CITY OF BRAMPTON
BUILDING DIVISION
REVIEWED BY: S. DESAI
MAR 05 2019
ATTACHED NOTES ARE PART
OF REVIEWED DRAWINGS
ALL WORK MUST COMPLY WITH OBC

Client
GREENPARK HOMES
Project Name
**MINNISALE HOMES CORP
BRAMPTON, ONTARIO**
**OPT 4 BED
HEMLOCK 3** 1928 sqft

Sheet Title
**BASEMENT
HEATING
LAYOUT**
Date
AUG/2018
Scale
3/16" = 1'-0"
BCIN# 19669
LO# 79573

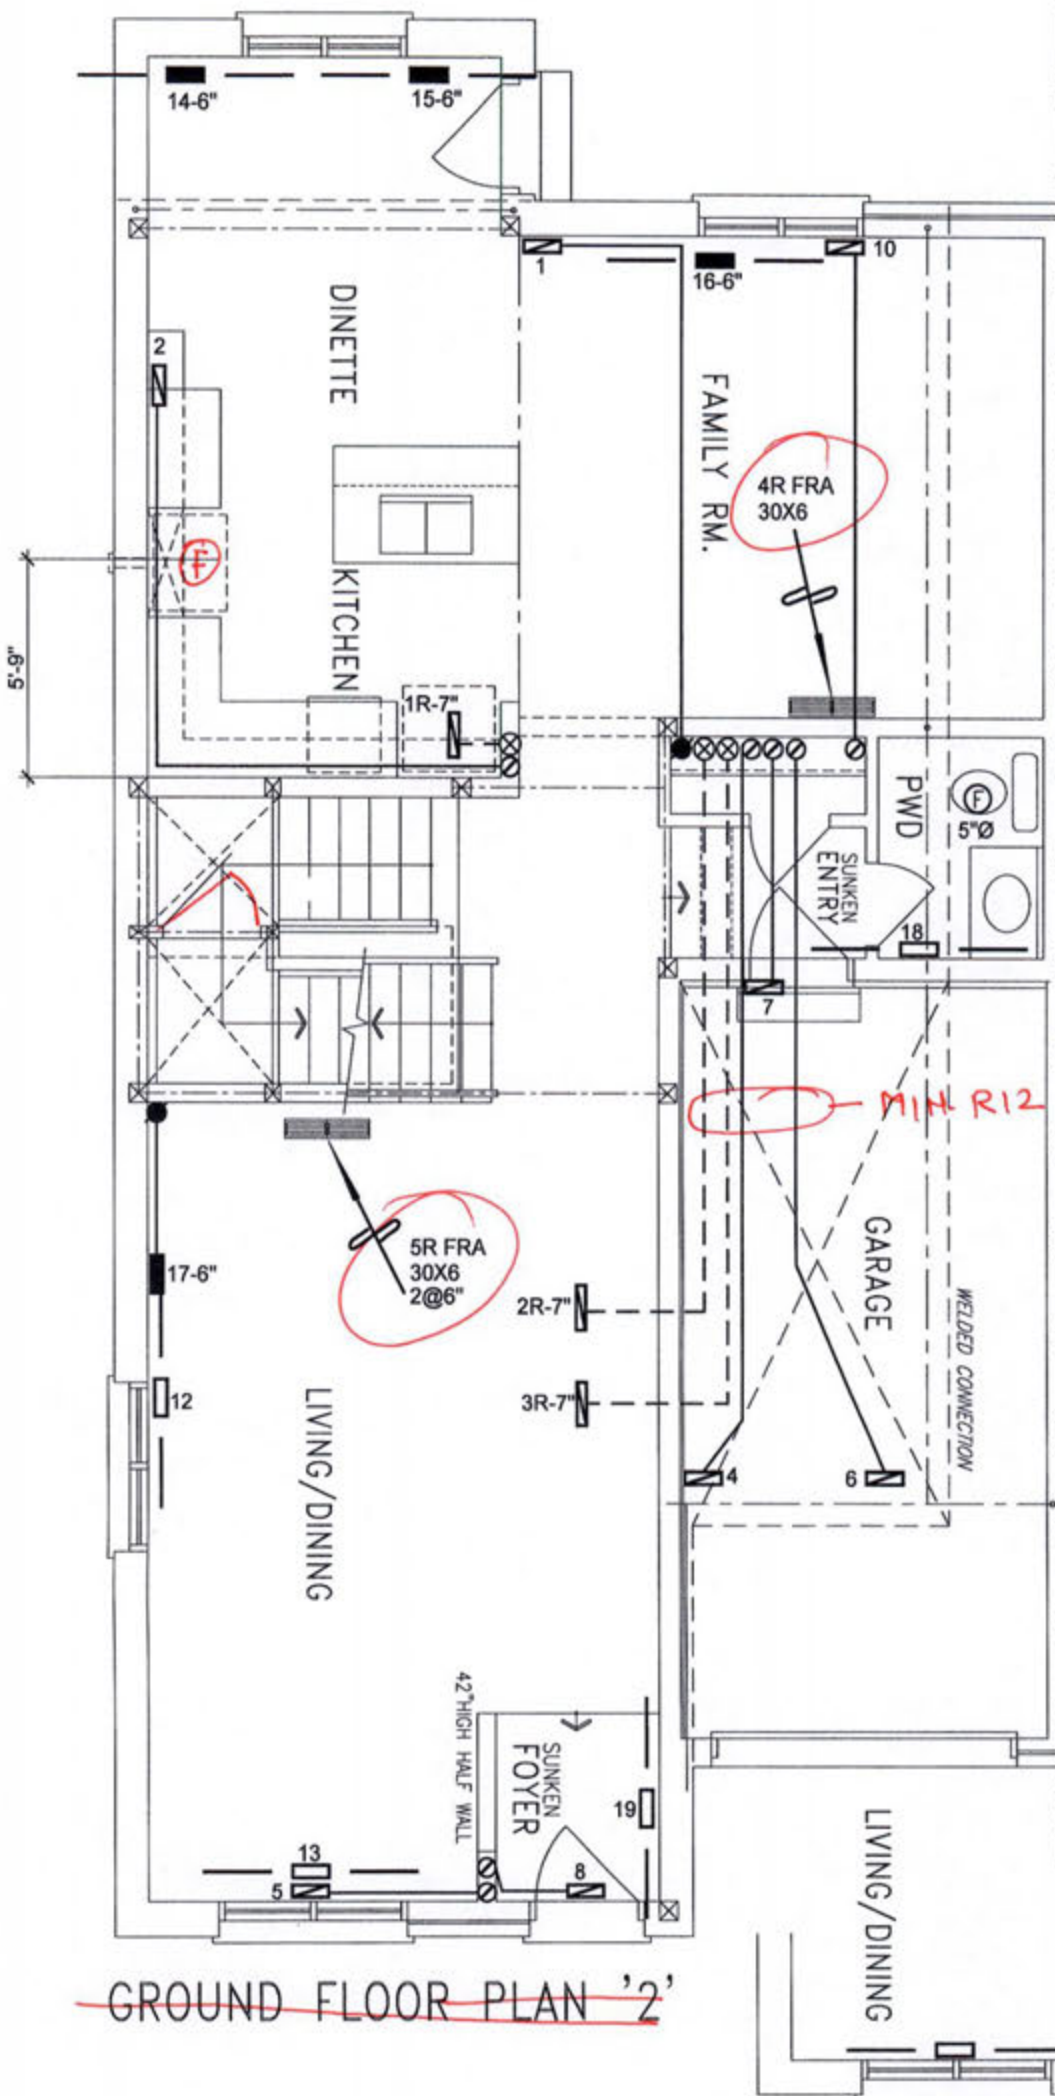
ENSURE THAT MIN THERMAL PERFORMANCE OF BLDG ENVELOPE AND EQUIPMENT SHALL CONFORM TO OBC S8-12, 3.1.2 TABLES REQUIREMENTS.
FURNACE SHALL BE EQUIPPED WITH BRUSHLESS DIRECT CURRENT MOTOR OBC DIV B 12.3.1.5.
SEAL ALL DUCTWORK WITHIN UNCONDITIONED SPACE or OUTDOORS PER OBC DIV B6.2.4.3(11) REQUIREMENTS. SEAL ALL SUPPLY DUCTS LOCATED IN CONDITIONED SPACE IN COMPLIANCE WITH OBC DIV B6.2.4.3(12) REQUIREMENTS.
SEPARATE ANY INTAKES FROM BUILDING ENVELOPE PENETRATIONS THAT ARE POTENTIAL SOURCES OF CONTAMINANTS (GAS VENTS, OIL FILL PIPES, etc. BY MIN 900mm (2FT 11IN) - OBC Div B 9.32.3.12.

INSTALLATION OF KITCHEN EXHAUST DUCT LARGER THAN 6" dia SHALL BE PRECEDED BY APPLICATION FOR REVISION OF DESIGN PER OBC PART 6 REQUIREMENTS. EXHAUST FAN SHALL DISCHARGE DIRECTLY TO OUTSIDE. CLOTHES DRYER EXHAUST SYSTEM SHALL COMPLY WITH OBC DIV B 9.32.1.2, 9.32.1.3 & 9.32.3 REQ'S. BALANCE THE RETURN AIRFLOW ON THE UPPER FLOOR TO MATCH THE SUPPLY.
WHEN HRV IS USED AS PRINCIPAL EXHAUST FAN, THE CONTROLLER SHALL BE WIRED TO THE HRV UNIT AND INTERCONNECTED TO THE FURNACE FAN. THE FURNACE BLOWER MUST BE IN OPERATION WHEN THE HRV IS IN OPERATION.
INSTALL ADDITIONAL SIA REGISTER AS REQUIRED IN ORDER TO ENSURE MIN 72degF UNDERCUT BY MIN 1" THE DOOR TO ANY ROOM WITHOUT RETURN AIR GRILLE. ENSURE RETURN AIR INTAKE SHALL BE CONNECTED TO THE MAIN R/A DUCT AT A HORIZONTAL DISTANCE OF MIN 6FT FROM THE CASING OF THE UNIT (HRAI DIGEST).

MECHANICAL VENTILATION SHALL BE PROVIDED IN
CONFORMANCE WITH OBC DIV. B, 9.32.3 REQUIREMENTS.

THE INSTALLATION OF CARBON MONOXIDE DETECTOR(S)
SHALL COMPLY WITH OBC DIV. B, 9.33.4 REQUIREMENTS.

A HEAT RECOVERY VENTILATOR SHALL BE INSTALLED IN
COMPLIANCE WITH OBC DIV. B, 6.2.1.6, 9.32.3.6(3), 9.32.3.11
AND HRAI DIGEST REQUIREMENTS.

INSTALLATION OF HVAC EQUIP.
SHALL CONFORM TO MANUFACTURER'S SPECIFICATIONS
AND MANUALS

GROUND FLOOR PLAN '1'

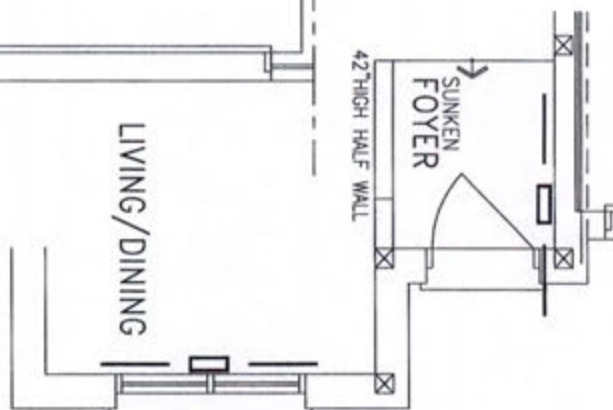
MECHANICAL VENTILATION SHALL BE PROVIDED IN
CONFORMANCE WITH OBC DIV. B, 9.32.3 REQUIREMENTS

THE INSTALLATION OF CARBON MONOXIDE DETECTOR(S)
SHALL COMPLY WITH OBC DIV. B, 9.33.4 REQUIREMENTS.

OPTIONAL SECOND FLOOR PLAN '1'
(4 BEDROOM)

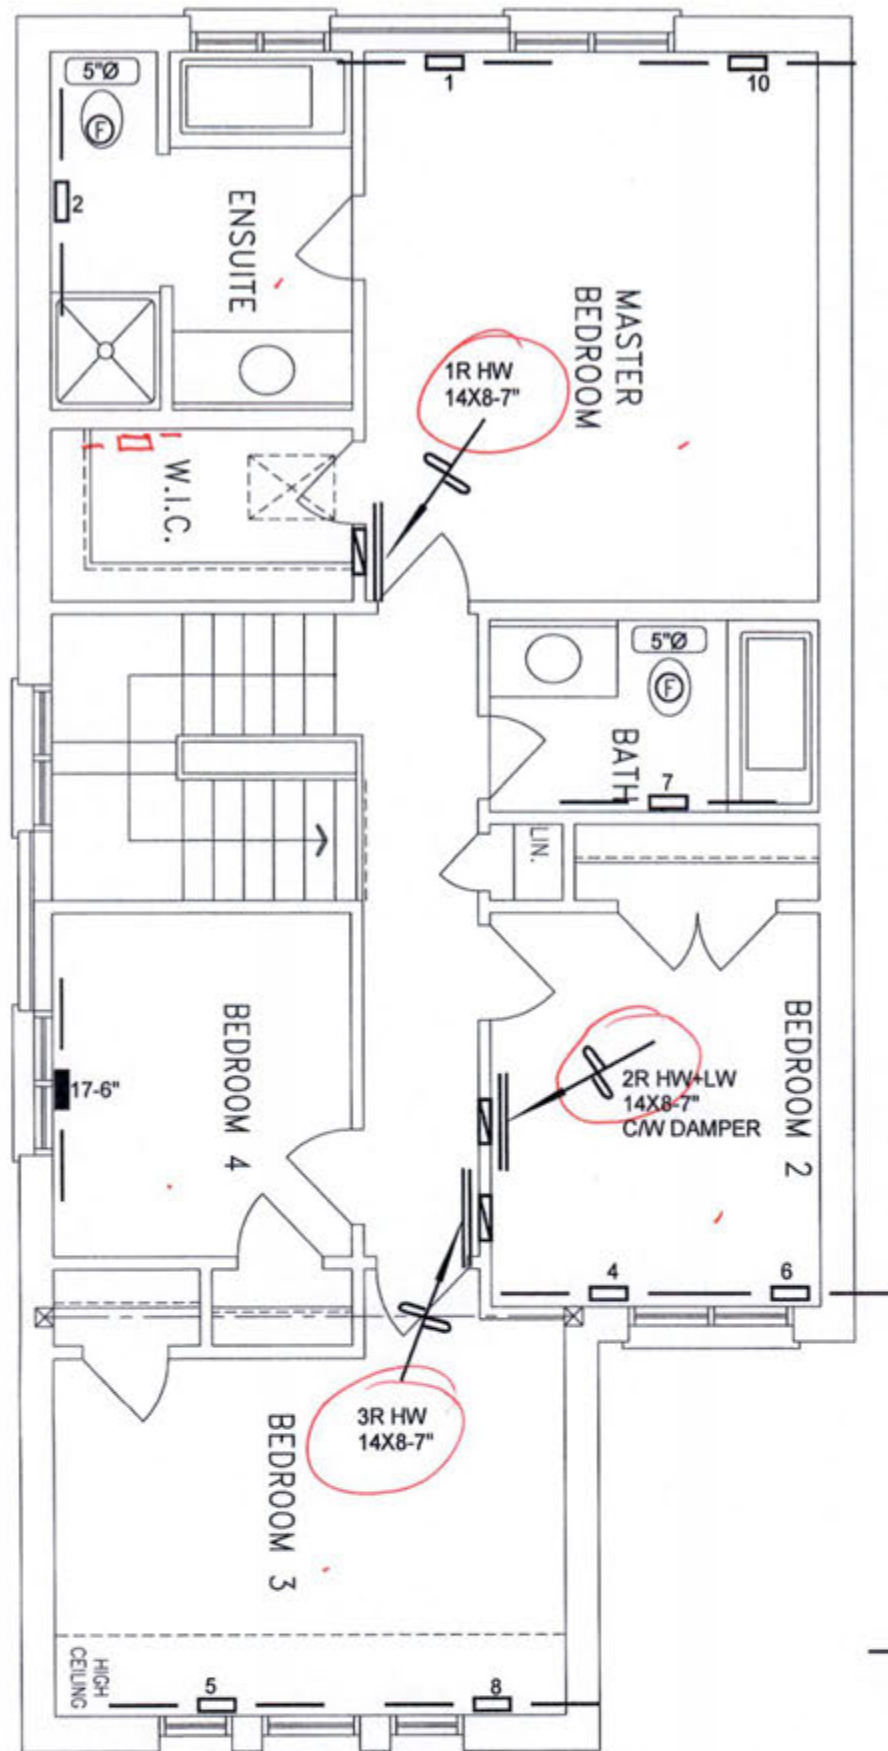
~~OPTIONAL SECOND FLOOR PLAN '2'~~
~~(4 BEDROOM)~~

MECHANICAL VENTILATION SHALL BE PROVIDED IN CONFORMANCE WITH OBC DIV. B, 9.32.3 REQUIREMENTS.

THE INSTALLATION OF CARBON MONOXIDE DETECTOR(S) SHALL COMPLY WITH OBC DIV. B, 9.33.4 REQUIREMENTS.
